Bristle Vale - update # 5

CITY OF LAS VEGAS INTER-OFFICE MEMORANDUM		DATE: May 14, 2020
TO: Land Development Services Department of Building & Safety		FROM: Jennifer Shinn, P.E.  Flood Control Project Engineer Department of Public Works
SUBJECT:	Drainage Study for: Bristle Vale – Update #5	
Cross Streets:	SEC of Crossbridge Drive & Alta Drive	
File Number:	F:\Depot\DSMemos\DS5039I.doc	
Parcel Number:	137-33-610-002, 137-33-610-003	
Zoning Action:	TMP-74073 & VAC-74072	
FEMA Flood Zone	YES	NO X
Proposed Storm Drain	YES X	NO
COPIES TO: Slater Hanifan Group		
		KB Home
		Bart Anderson, P.E., DevCo

8th Submittal: Update #5 for storm drain and drop inlet revisions based on as-built conditions.

Technical Drainage Study Update No.5

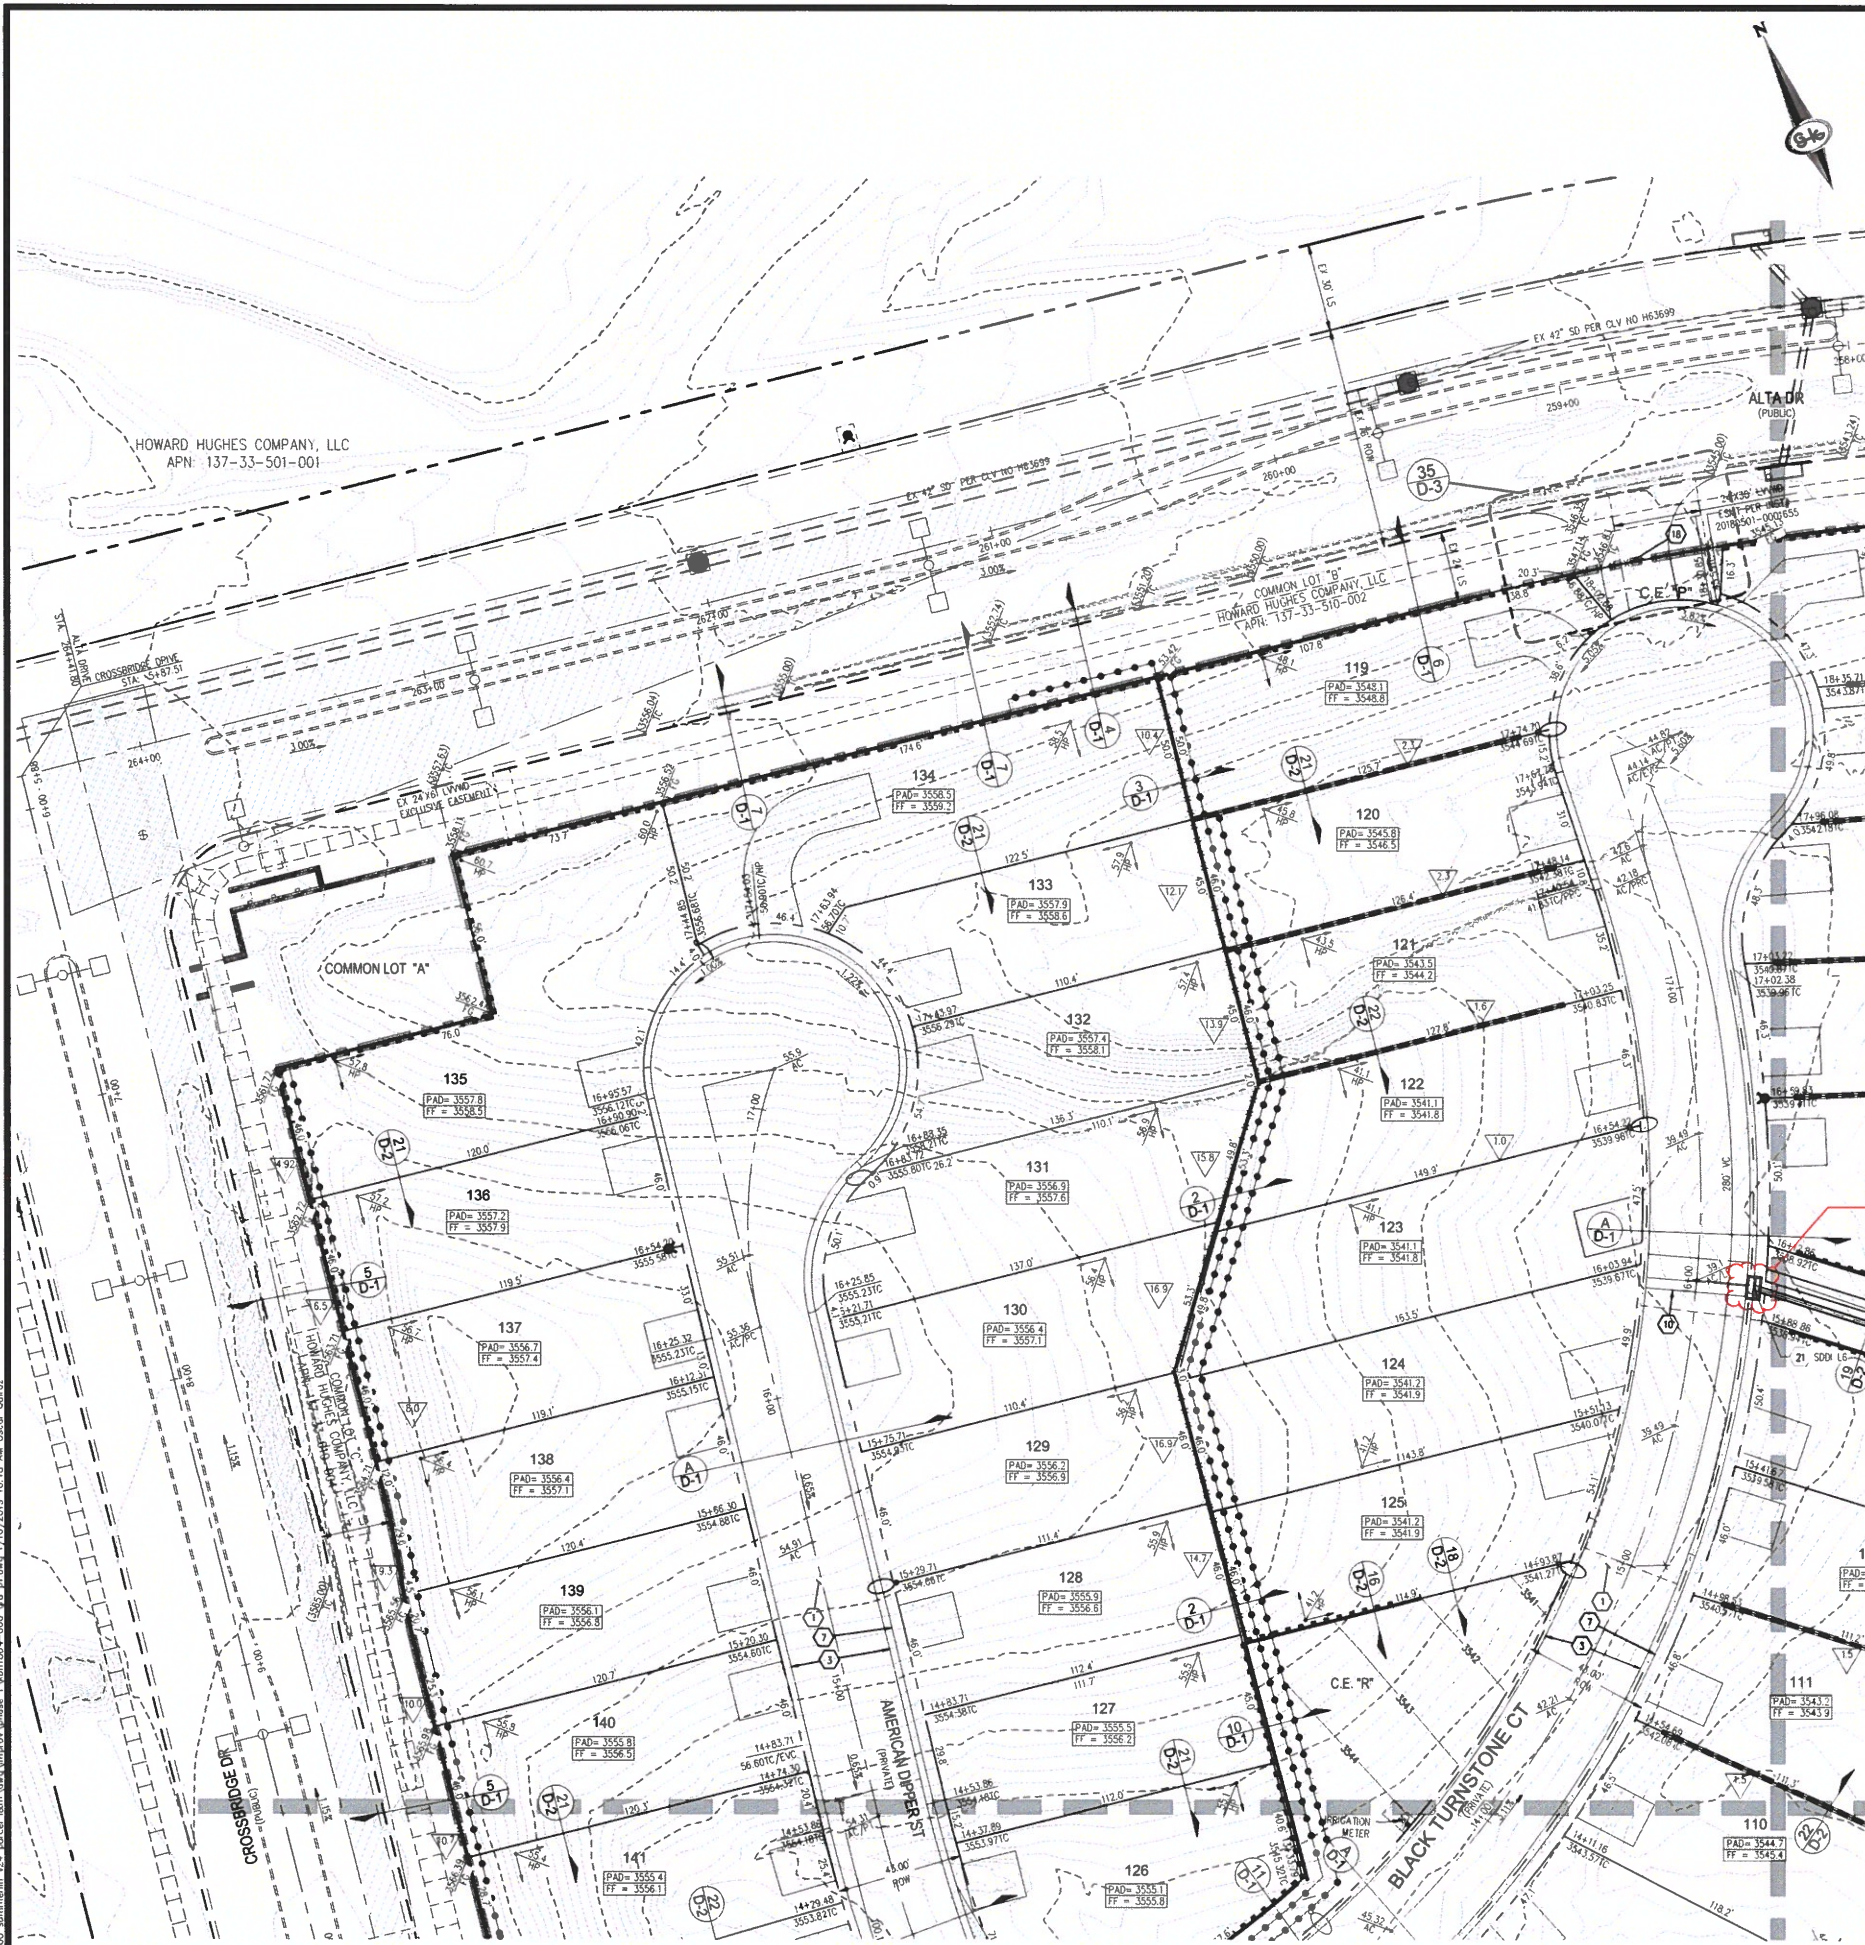
Change in size of DI
